Access Compliance Report

Public Rights-of-Way

(Island Curb Cuts)

Intersection ID: 17196	Main Street: IDLEWILD_RD	Cross Street: CONFERENCE_DR	Location: NW
ADA ID: A0B2E1D4E882	Curb Cut Type: IslandRefuge3	Initial Pass/Fail: Fail	Overall Compliance: No
Severity Score: 36.25			
Codes/Mitigation Info/Possible Solution		Field Measurements/Component Compliance

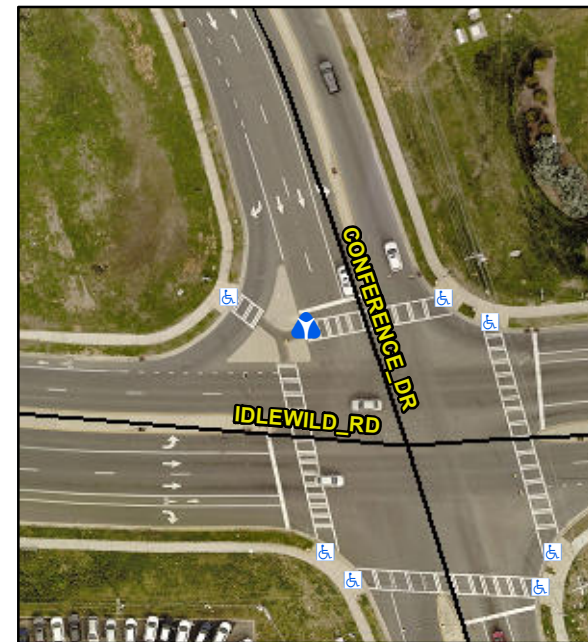
Compliance	Description	Data	Compliance	Description	Data
Yes	Refuge 1 Length (In)	120.0	N/A	Gutter 1 Ponding?	N/A
Yes	Refuge 1 Width (In)	60.0	N/A	Gutter 1 Lip Ht (In)	N/A
Yes	Refuge 1 Slope (%)	2.2	N/A	Gutter 1 Slope (%)	N/A
Yes	Refuge 1 X Slope (%)	2.9	N/A	Gutter 1 X Slope (%)	N/A
N/A	Painted X Walk1?	Yes	N/A	DWS 1 Provided?	N/A
N/A	X Walk 1 Direction	To E	N/A	DWS 1 Contrast?	N/A
N/A	X Walk 1 Width (In)	111.0	N/A	DWS 1 Length (In)	N/A
N/A	Road 1 Slope (%)	1.3	N/A	DWS 1 Full Width?	N/A
N/A	Road 1 X Slope (%)	2.6	N/A	DWS 1 Offset (In)	N/A
Yes	Refuge 2 Length (In)	122.0	N/A	Gutter 2 Ponding?	N/A
Yes	Refuge 2 Width (In)	61.0	N/A	Gutter 2 Lip Ht (In)	N/A
Yes	Refuge 2 Slope (%)	1.2	N/A	Gutter 2 Slope (%)	N/A
Yes	Refuge 2 X Slope (%)	2.0	N/A	Gutter 2 X Slope (%)	N/A
N/A	Painted X Walk2?	Yes	N/A	DWS 2 Provided?	N/A
N/A	X Walk 2 Direction	To S	N/A	DWS 2 Contrast?	N/A
N/A	X Walk 2 Width (In)	110.0	N/A	DWS 2 Length (In)	N/A

N/A	Road 2 Slope (%)	2.7	N/A	DWS 2 Full Width?	N/A
N/A	Road 2 X Slope (%)	2.7	N/A	DWS 2 Offset (In)	N/A
Yes	Refuge 3 Length (in)	138.0	N/A	Gutter 3 Ponding?	N/A
Yes	Refuge 3 Width (in)	61.0	N/A	Gutter 3 Lip Ht (in)	N/A
Yes	Refuge 3 Slope (%)	1.7	N/A	Gutter 3 Slope (%)	N/A
Yes	Refuge 3 XSlope (%)	4.5	N/A	Gutter 3 XSlope (%)	N/A
N/A	Painted X Walk3?	Yes	N/A	DWS 3 Provided?	N/A
N/A	X Walk 3 Direction	To NW	N/A	DWS 3 Contrast?	N/A
N/A	X Walk 3 Width (in)	110.0	N/A	DWS 3 Length (in)	N/A
N/A	Road 3 Slope (%)	4.2	N/A	DWS 3 Full Width?	N/A
N/A	Road 3 XSlope (%)	0.3	N/A	DWS 3 Offset (in)	N/A
Yes	Any Obstructions?	N/A	N/A	Storm Grate/Utility Hazard?	N/A
N/A	Obstruction Type		N/A	Storm Grate/Utility Type	
		N/A			N/A
N/A	Surface Condition	Good

Remove & Replace Entire Refuge.
